Addendum

ADDENDUM NO.

1

PROJECT 178007.000 | Starr County Memorial Hospital – MRI Addition and Renovation

1 MECHANICAL PLAN - ADD ALTERNATES 2 AND 4
M-2.3 3/16"=1'-0"

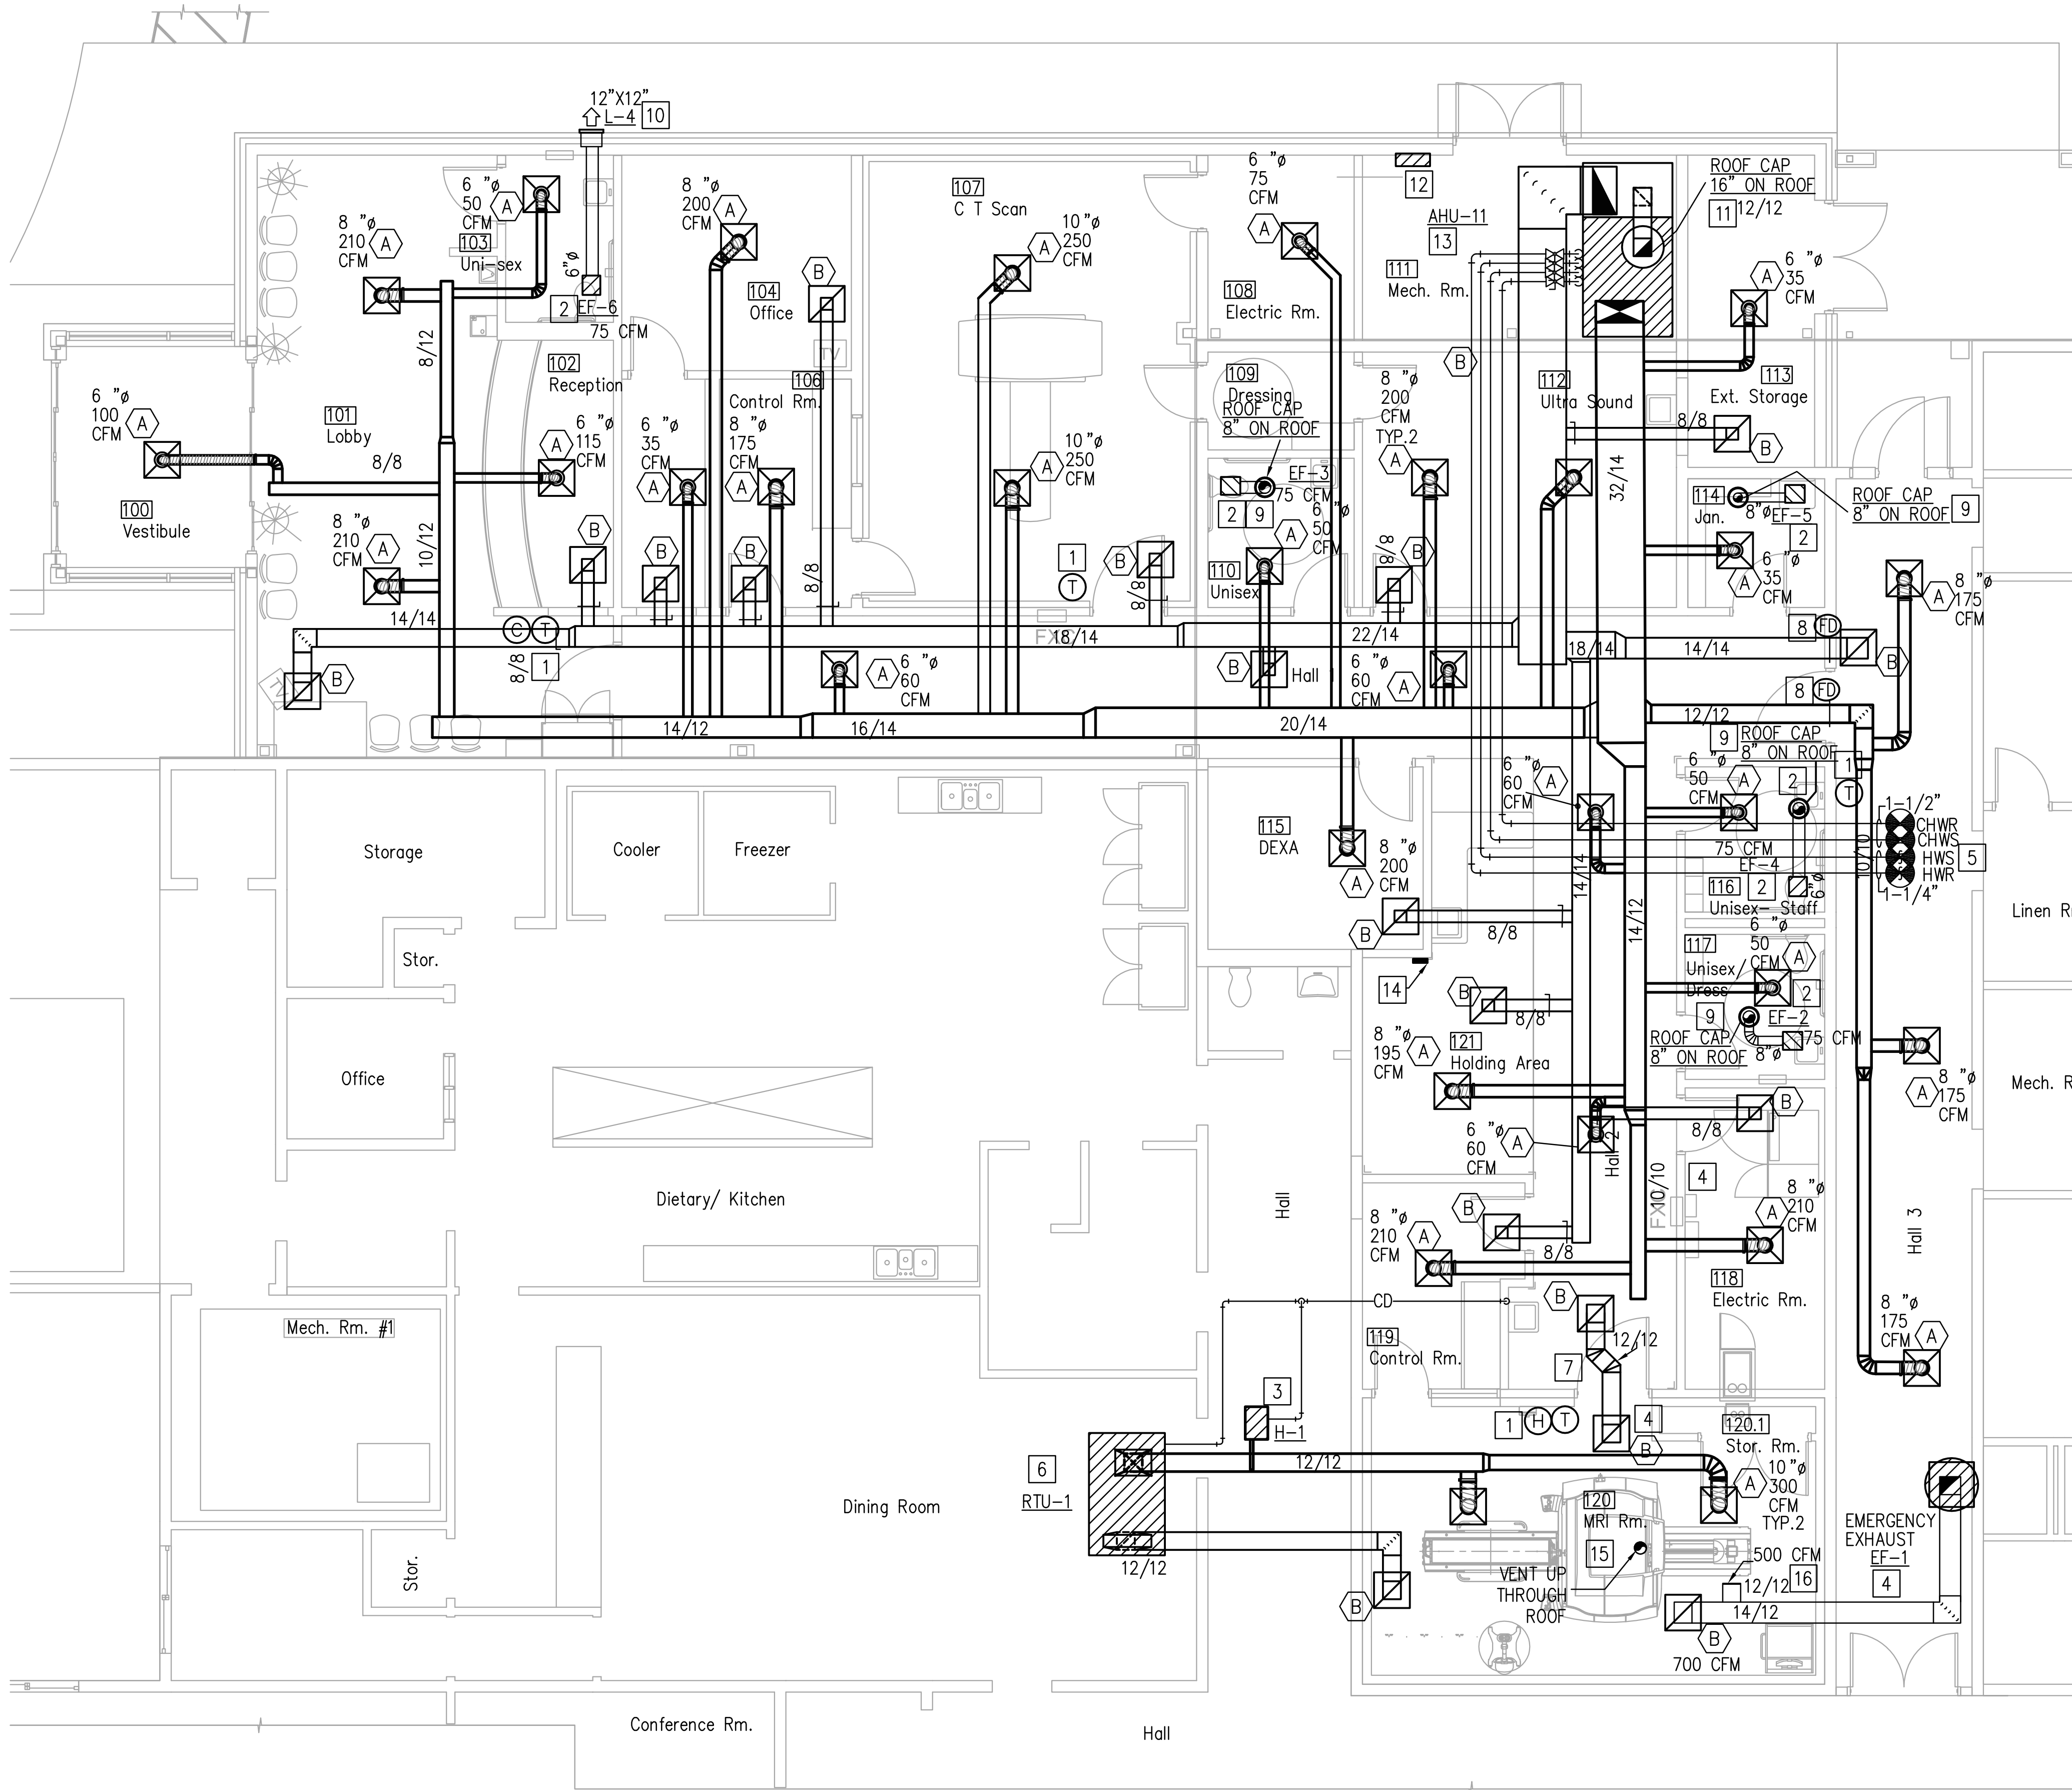
Item 03 Sheet M2.3 – Mechanical Plan – Add Alternates 2 and 4

- A. Replace in its entirety.
- B. RTU's and AHU's have been reselected.
- C. Relocated AHU-10 from the ceiling down to a mechanical closet.
- D. AHU-10 shall be part of alternate #2.

MECHANICAL PLAN - AREA 1 - BASE BID
M-2.1 3/16"=1'-0"

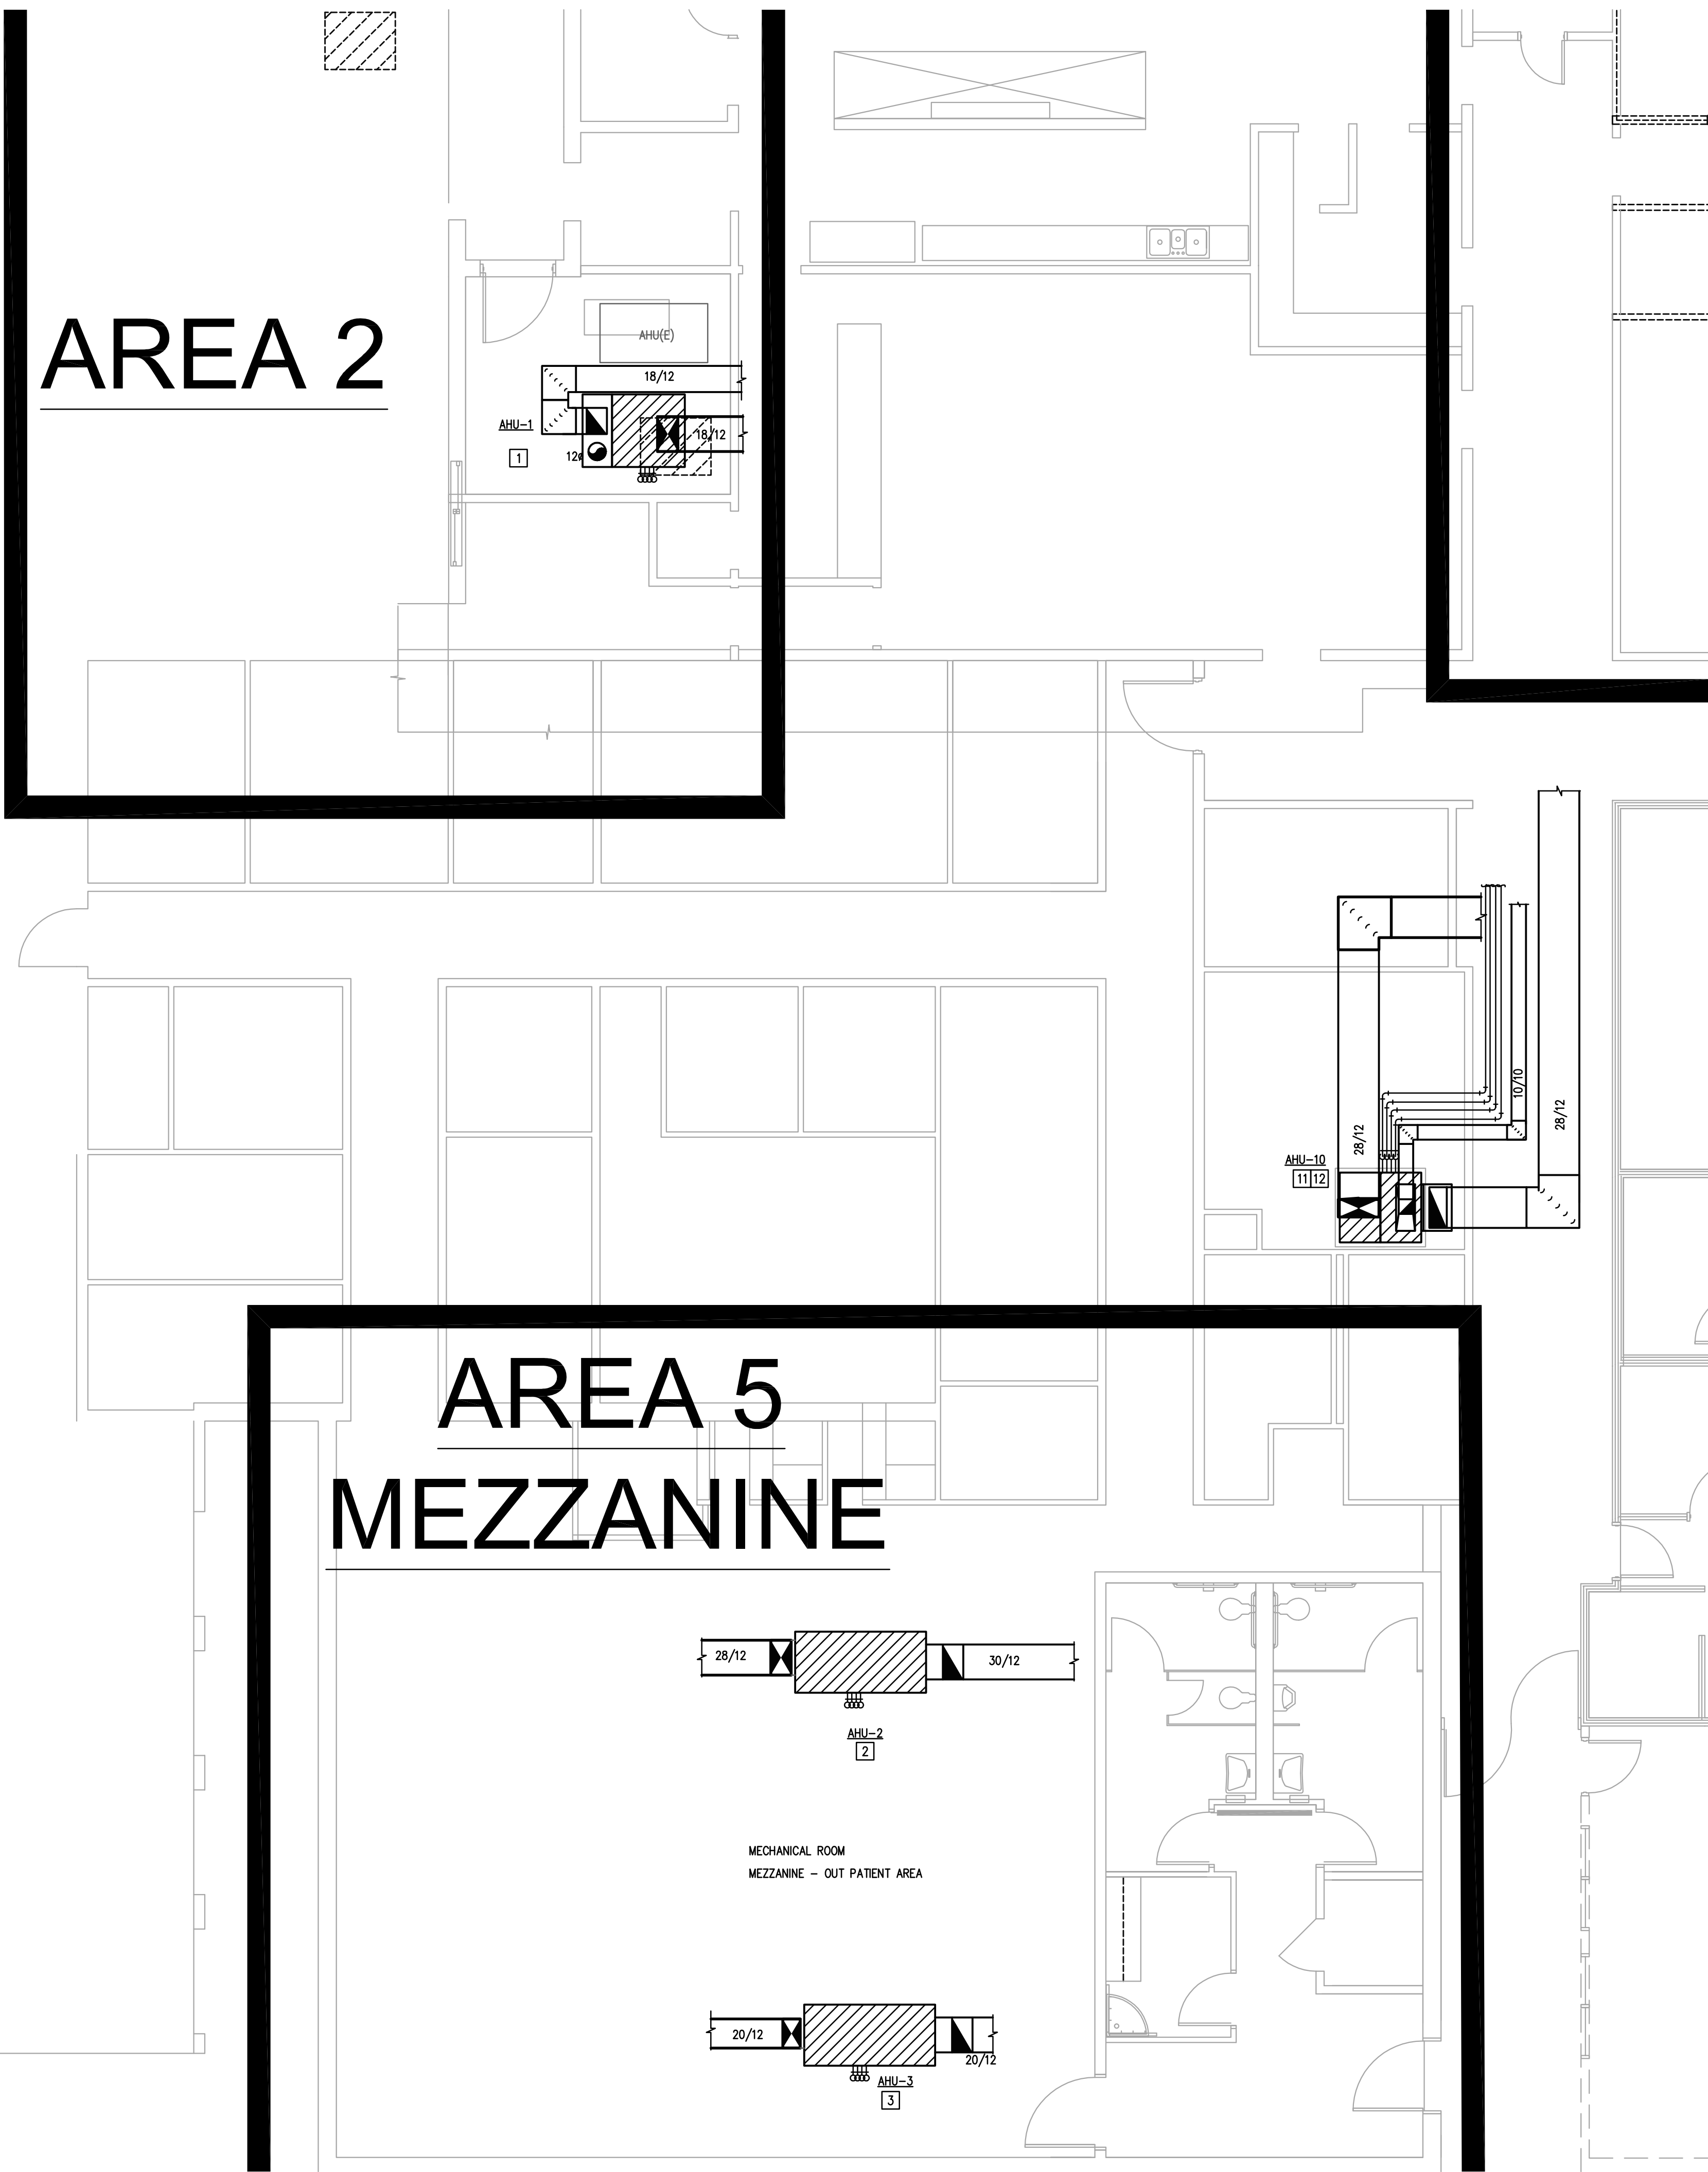
Item 01 Sheet M2.1 – Mechanical Plan – Area 1 – Base Bid

- A. Replace in its entirety.
- B. RTU's and AHU's have been reselected.

1 ELECTRICAL OVERALL PLAN

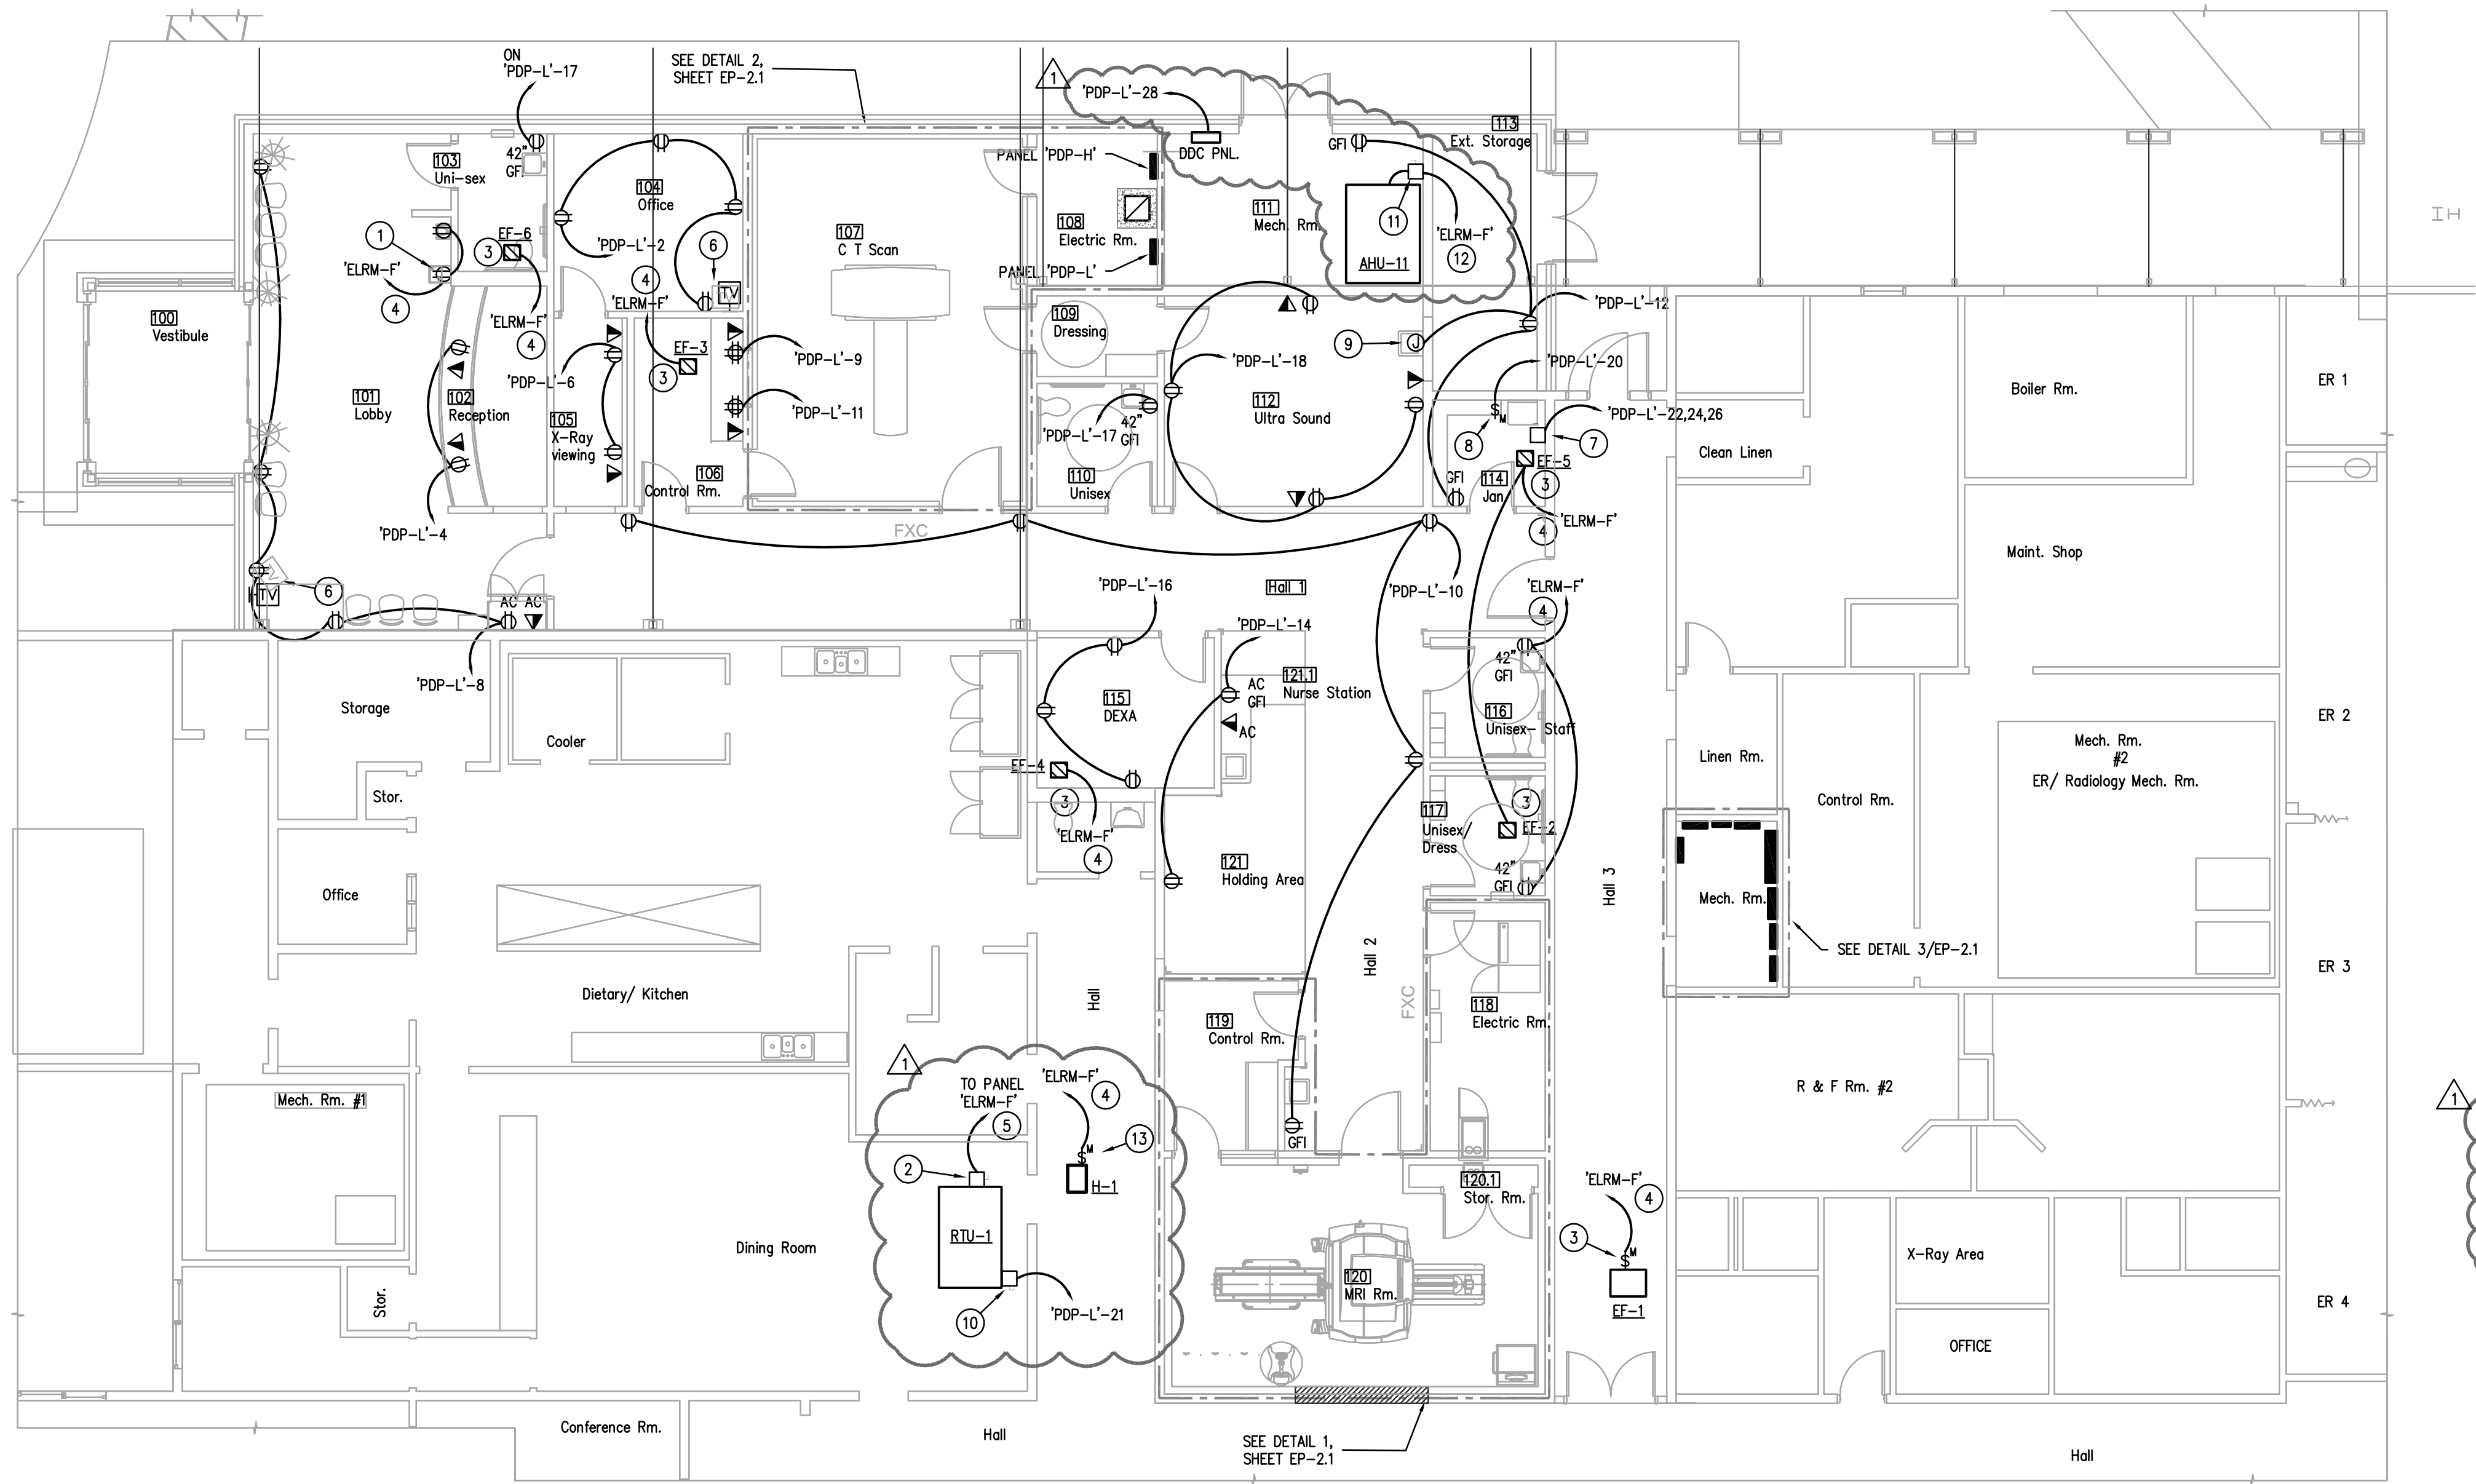
Item 05 Sheet EP-1 – Electrical Overall Plan

- A. Replace in its entirety.
- B. RTU's and AHU's have been reselected.
